REMARKS

The specification and drawings are amended in response to the various objections raised in paragraphs 1 and 2 of the Office Action. Revised drawings sheets and annotated marked-up drawing sheets are submitted under an appended paper.

FIG. 4(B)

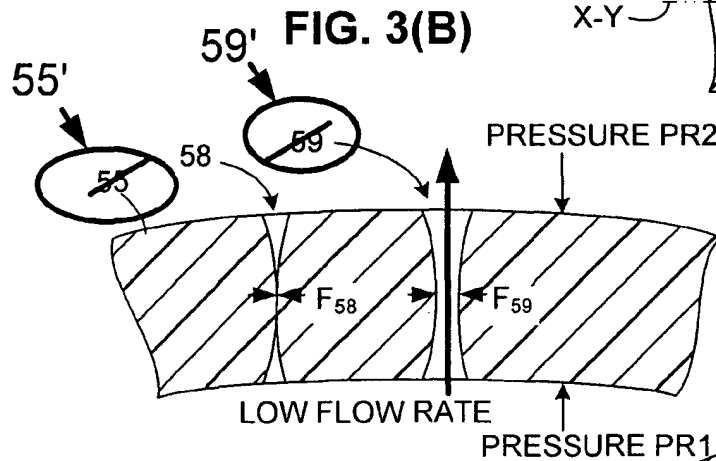
In response to paragraph 1a of the Office Action, Fig. 4(B) is amended to change "55" and "59" to "55'" and "59'".

FIG. 5

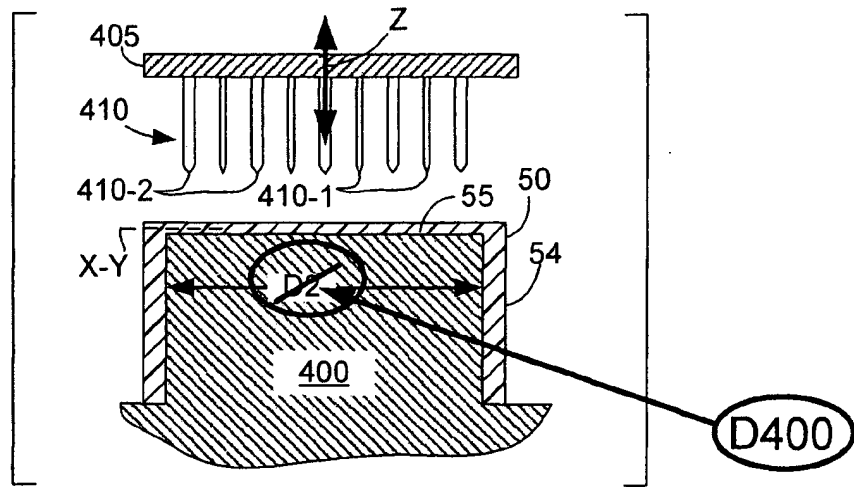
In response to paragraph 1 of the Office Action, Fig. 5 and paragraph 0042 are amended to change D1 to D400, and Fig. 8 and paragraph 0046 are amended to change D1 to D3, and D3 to D4 (D2 is deleted).

In response to paragraph 1a of the Office Action, Fig. 5 is amended to change "158'" and "159'" to "158" and "159", and Figs. 14 and 15 are amended to omit "356", "445", and "446".

FIG. 8

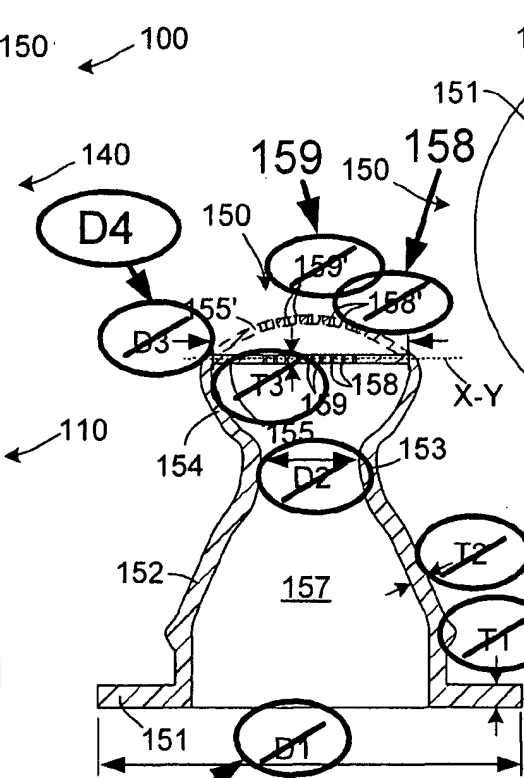
In response to the objections raised in paragraph 2, see the amendments mentioned above regarding D1 and D2. In addition, regarding T1, Fig. 8 and paragraph 0046 are amended to change T1 to T3, and T2 to T4 (T3 is deleted).
